Revision history: (Compared to ver 2.0A)

TEXAS INSTRUMENTS			Texas Instruments 66/3 Bagmane Tech Park CV Raman Nagar Bangalore		91-80-2509-9599
	Approval	Date	Title CC3101	LP Ver 3.0 ENG1	
Designer	Prajay M	Date	OCCIOTED VEI 3.0 ENGT		
Drawn By	Prajay M	Date	Size A2	Project No <project number=""></project>	Rev B
Layout	Tessolve	Date	Scale	Date Thursday, January 16, 20	14 Sheet 1 of 6

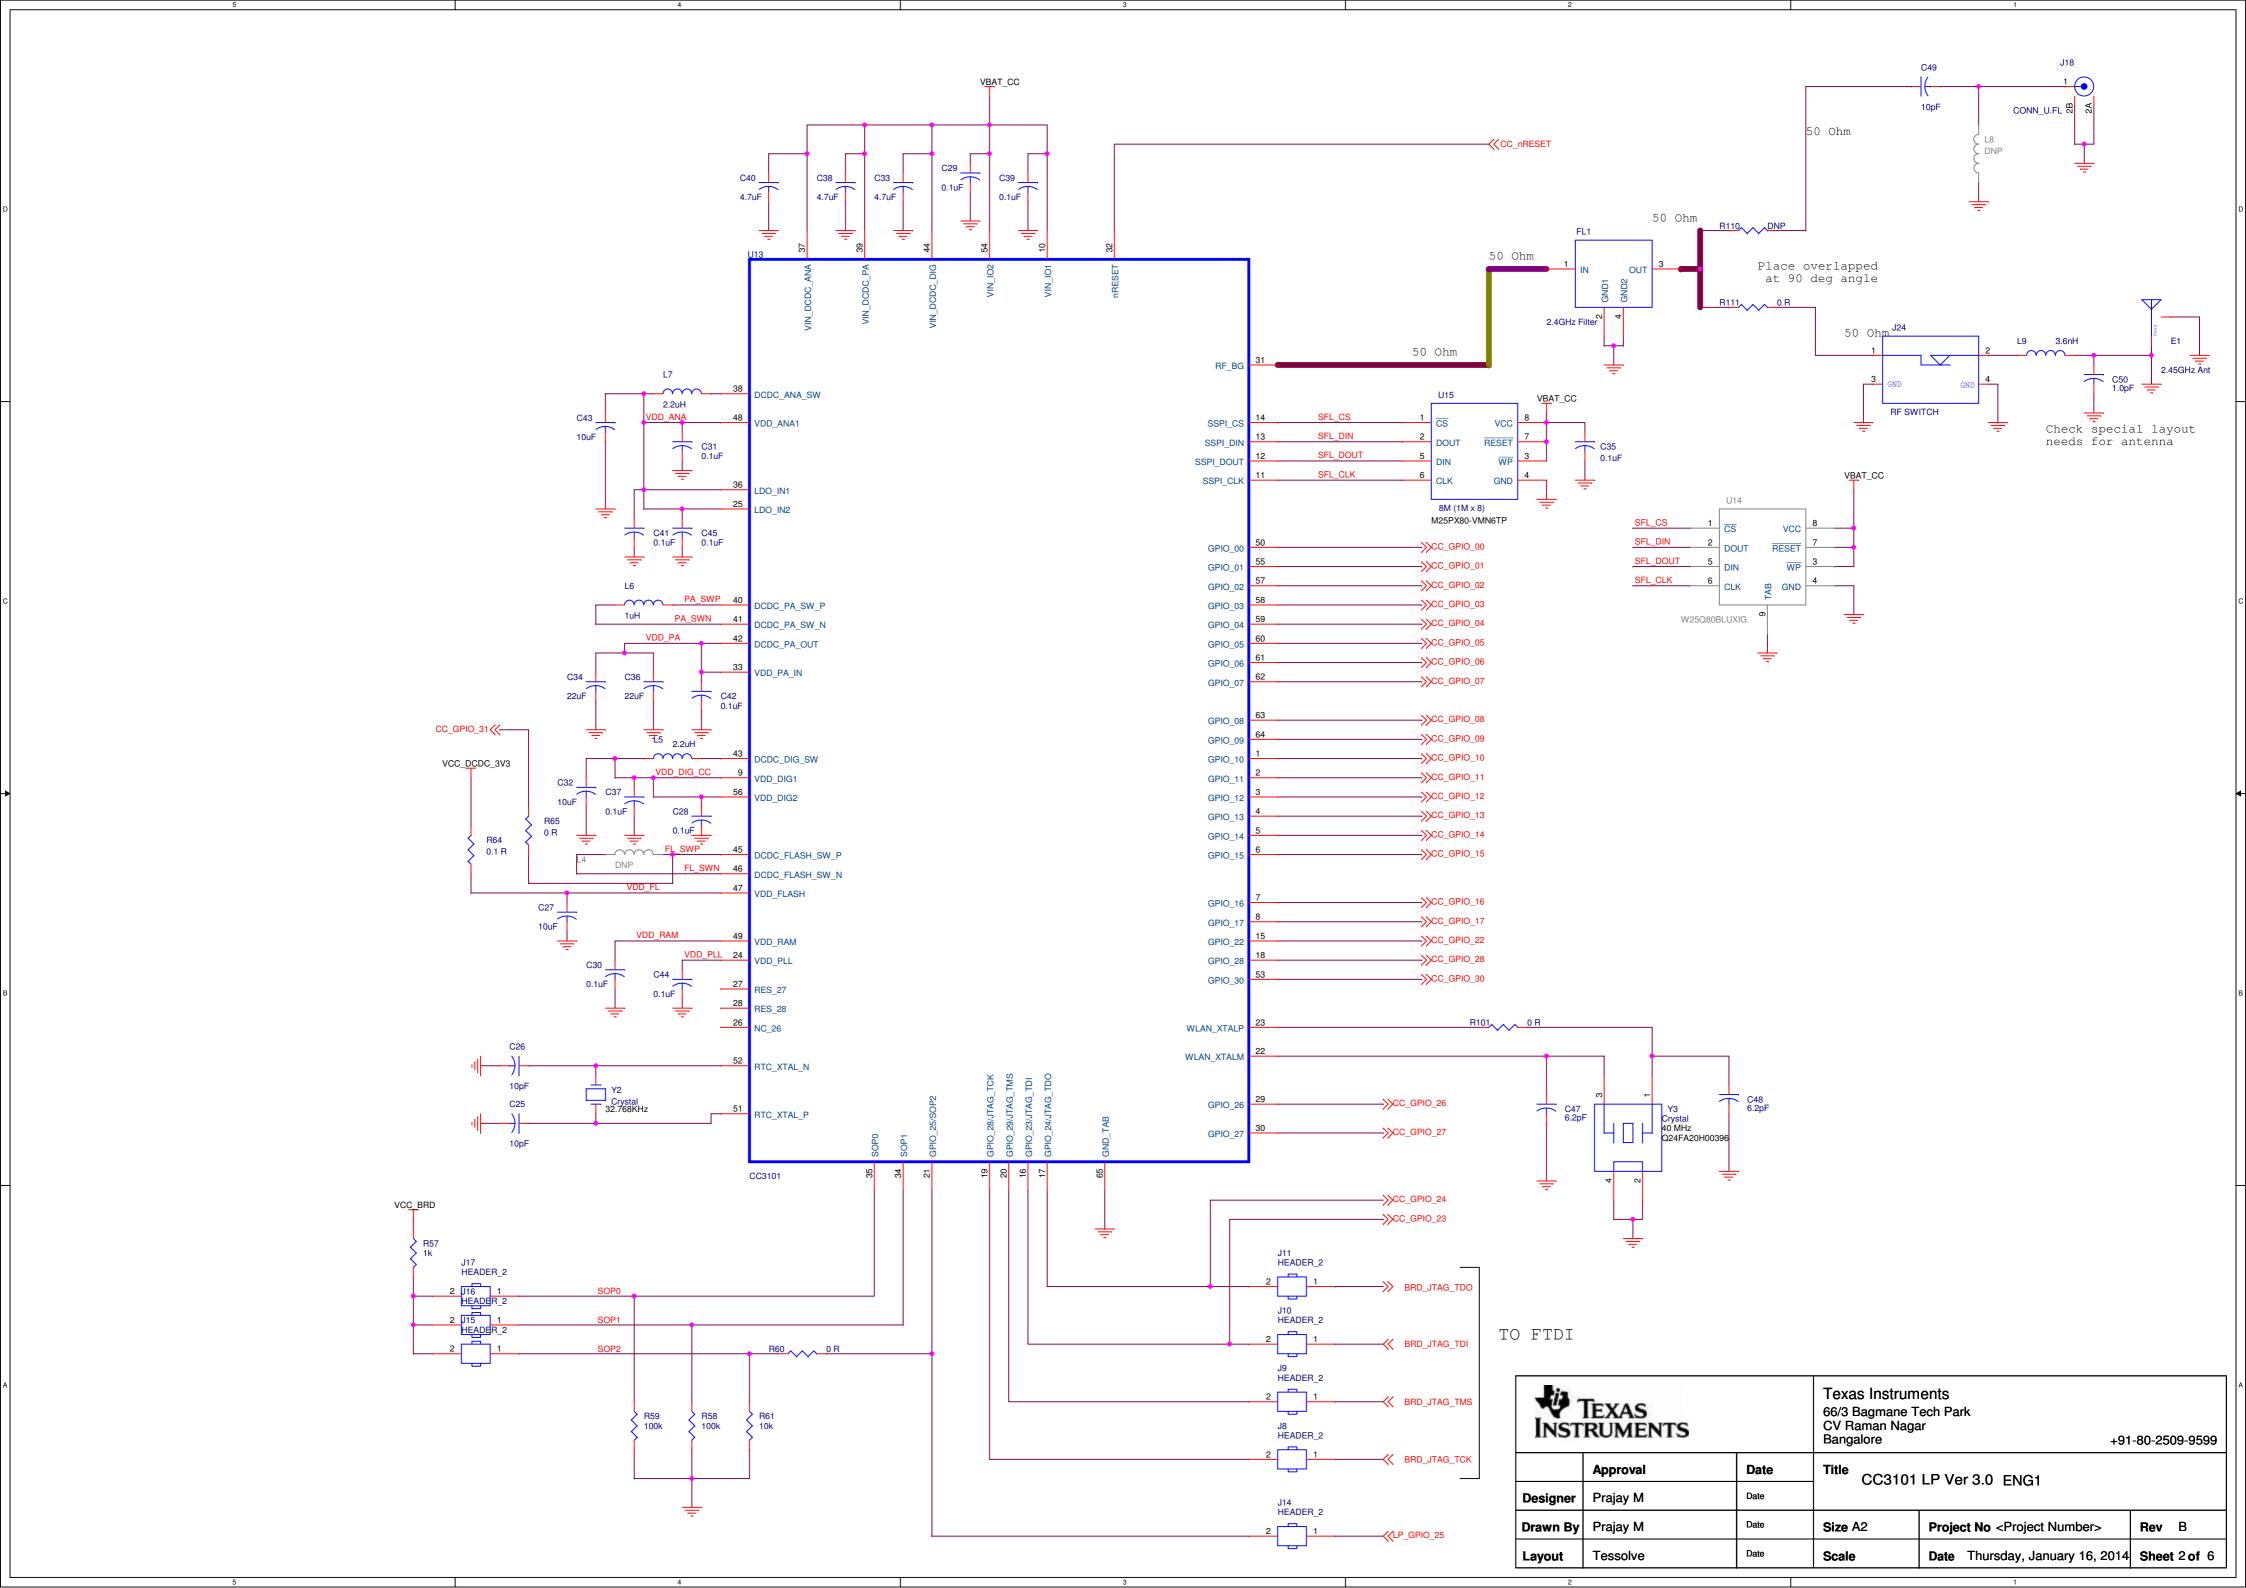
- 1. Replaced Emualtion circuit with FTDI instead of ICDI
 2. Re-arranged the pin assignment of the P1,P2,P3,P4 to align with the MCU convention.
 3. Added pull-down on the LED driver to prevent them from floating.
 4.
